Mobile Intel[®] Pentium[®] II Processor Specification Update

Release Date: May 2001

Order Number: 243887-031

The Mobile Pentium[®] II processor may contain design defects or errors known as errata which may cause the product to deviate from published specifications. Current characterized errata are documented in this Specification Update.

Old Mobile Pentium® II Processor in Mini-Cartridge Package Label with Supplier Matrix Mark

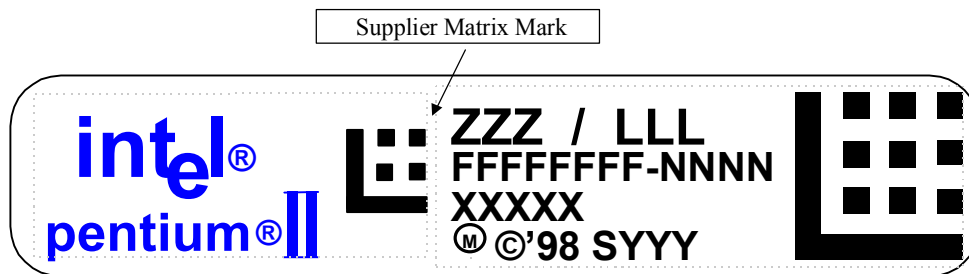
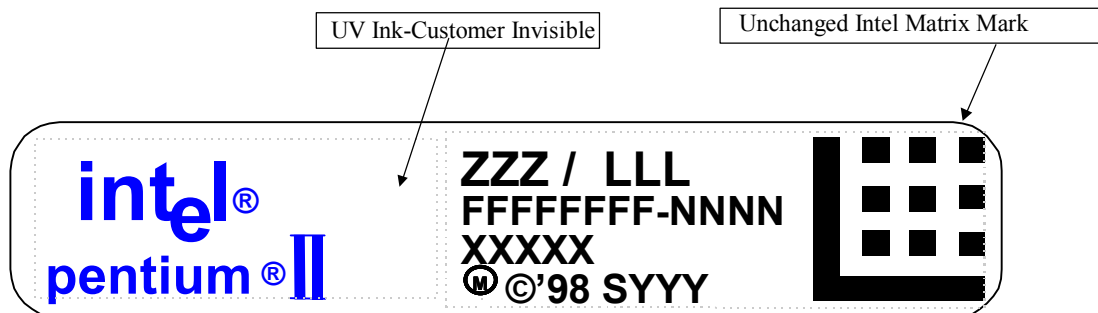
New Mobile Pentium® II Processor in Mini-Cartridge Package Label with Supplier Matrix Mark Removed

Figure 2. Workaround Flowchart: SMBALERT#-Driven System

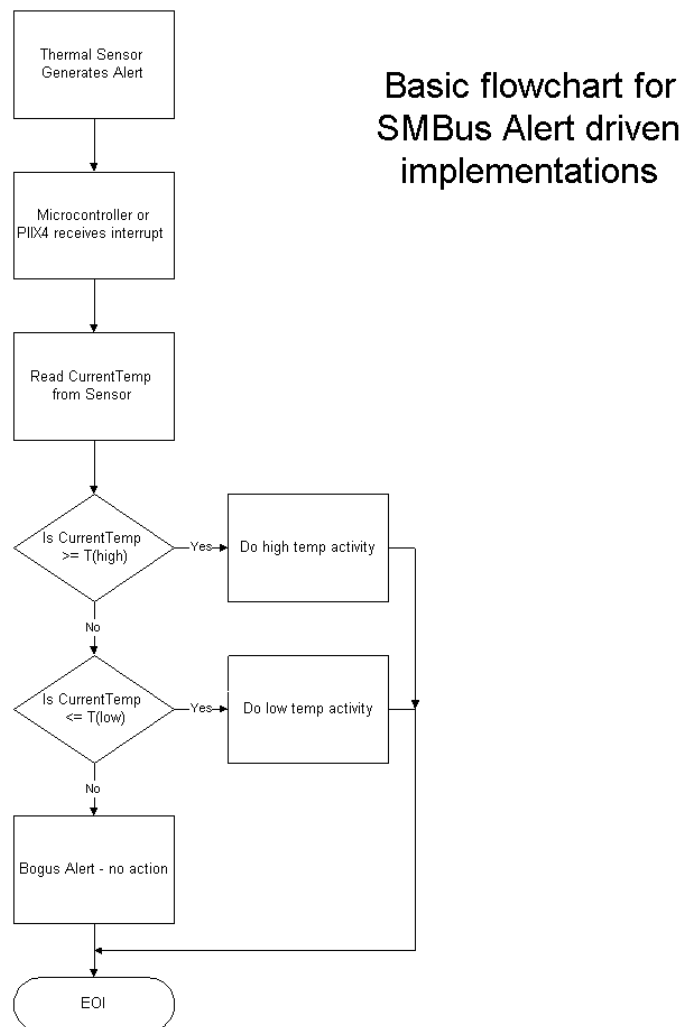
B30. Thermal Sensor May Assert SMBALERT# Incorrectly

Under the conditions described below, the thermal sensor incorrectly generates the SMBALERT# interrupt. All of the following conditions must be met to trigger a false interrupt:

1. Before servicing an interrupt from the thermal sensor, read and compare the processor thermal reading with the threshold limits (T_{HIGH} or T_{LOW}). Figures 2 and 3 provide basic flowcharts for the implementation of this workaround in an interrupt driven system.
2. If the firmware implemented polls the Status Register only, then before taking any action, re-read the temperature register and do a comparison with the alarm threshold limits (T_{HIGH} or T_{LOW}) to determine if the value is actually still within the temperature window.

3. Use a temperature polling scheme to monitor the processor temperature.

Figure 5.6. Cross Sectional View with Vertical Dimensions

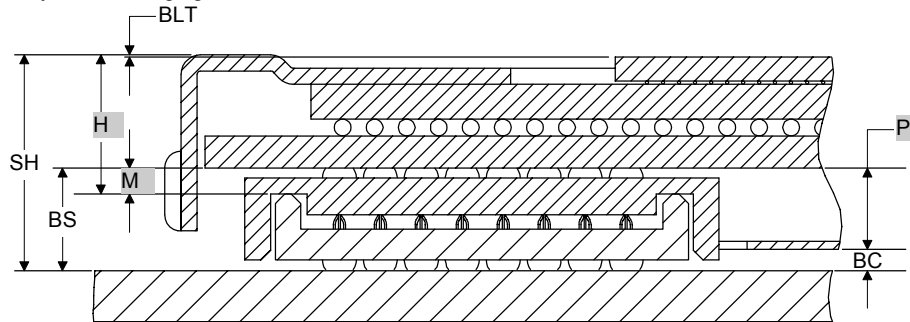
B1. Misabeled Vertical Dimension Parameters

Figure 5.6 in the *Mobile Pentium® II Processor at 233 MHz, 266 MHz, and 300 MHz* datasheet should be replaced by the following figure:

Figure 5.3. Surface-Mount BGA1 Package—Top and Side View

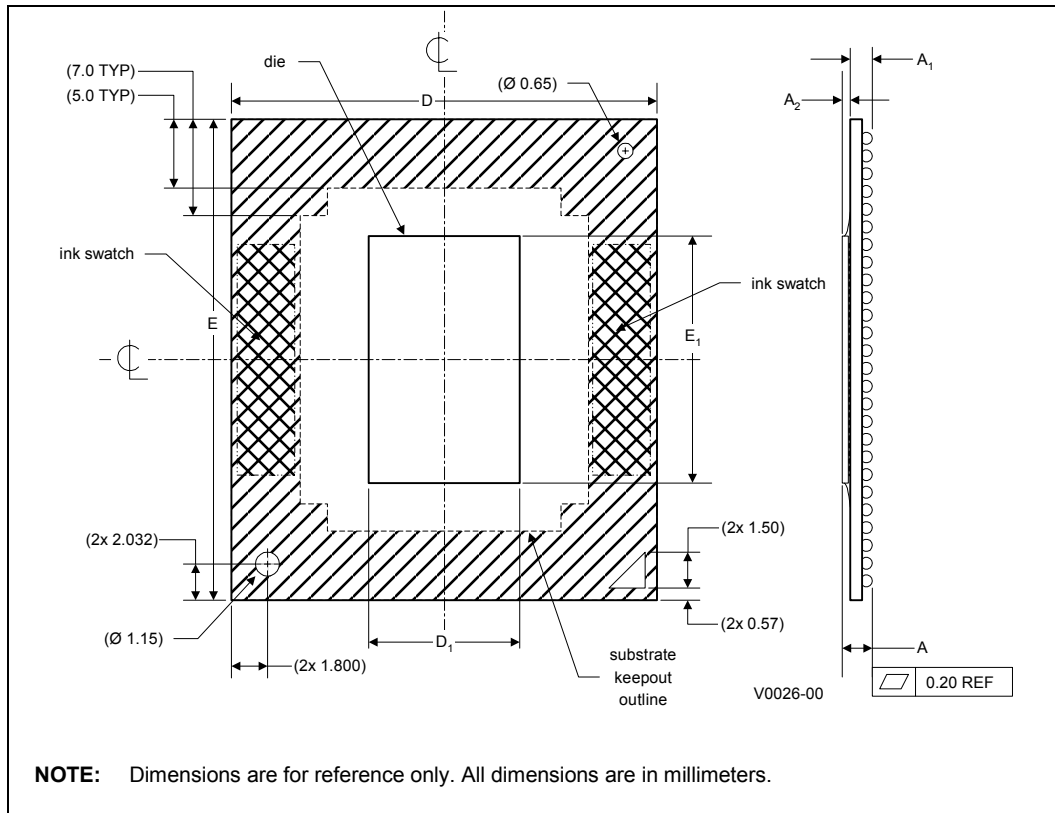
The following table and figures show the updated mechanical specifications for the BGA1 package, listed as Table 5.2, Figure 5.3 and Figure 5.4, respectively, in the *Mobile Pentium® II Processor in BGA Package at 366 MHz, 333 MHz, 300PE MHz, and 266PE MHz* datasheet.

1. The number shown here is different from that in the 243887-010 revision of this specification update. The maximum reference number is used.

Figure 3.3 Generic Clock Waveform

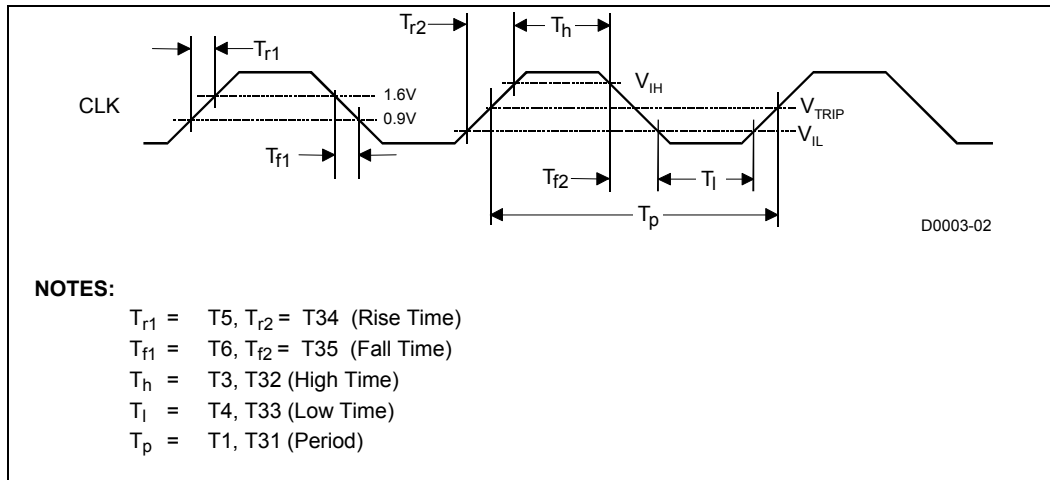
B14. Generic Clock Waveform Figure

Figure 3.3 in *Mobile Pentium® II Processor in Mini-Cartridge Package at 366 MHz, 333 MHz, 300PE MHz, and 266PE MHz* datasheet (Order Number 245108), and the *Mobile Pentium® II Processor in BGA Package at 366 MHz, 333 MHz, 300PE MHz, and 266PE MHz* datasheet (Order Number 245106) has been updated. The following figure is to replace the ones in the above documents.

Figure 1. TAP Gageable Thread Clarification

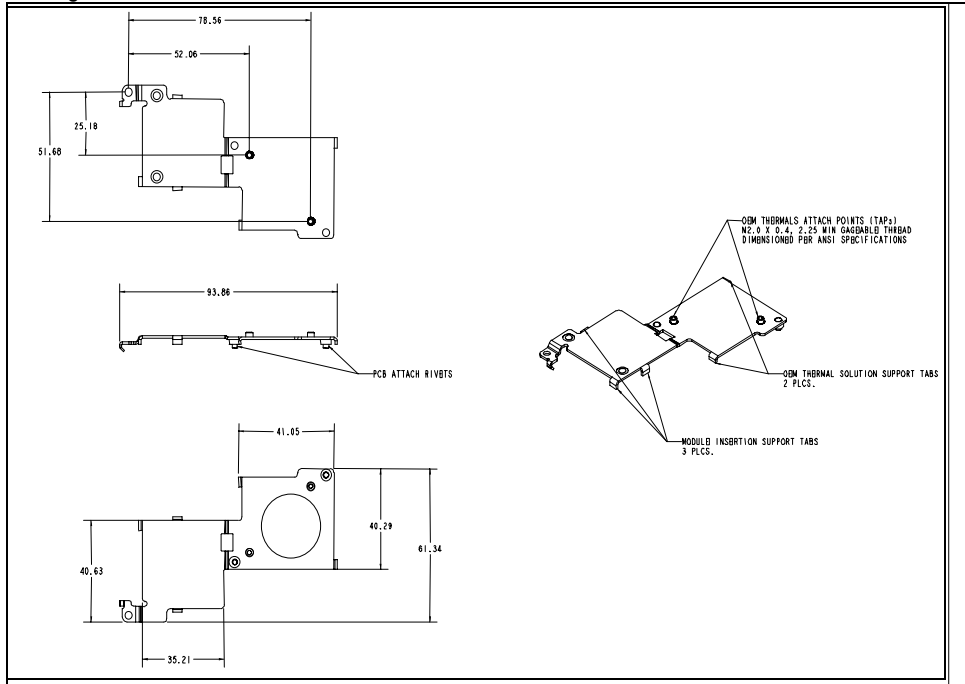
In the *Intel® Pentium® II Processor Mobile Module : Mobile Module Connector 1 (MMC-1)* and the *Intel® Pentium® II Processor Mobile Module : Mobile Module Connector 2 (MMC-2)* datasheets (Order Numbers 243667 and 243668, respectively), the thermal attach point (TAP) gageable thread specification was not clearly identified in Figure 14, of Section 5.2. The following is the TAP clarification:

See Figure 1 below for more information.

OEM Thermal Attach Points (TAPs) M2.0 x 0.4, 2.25 min gageable thread dimensioned per ANSI specification.
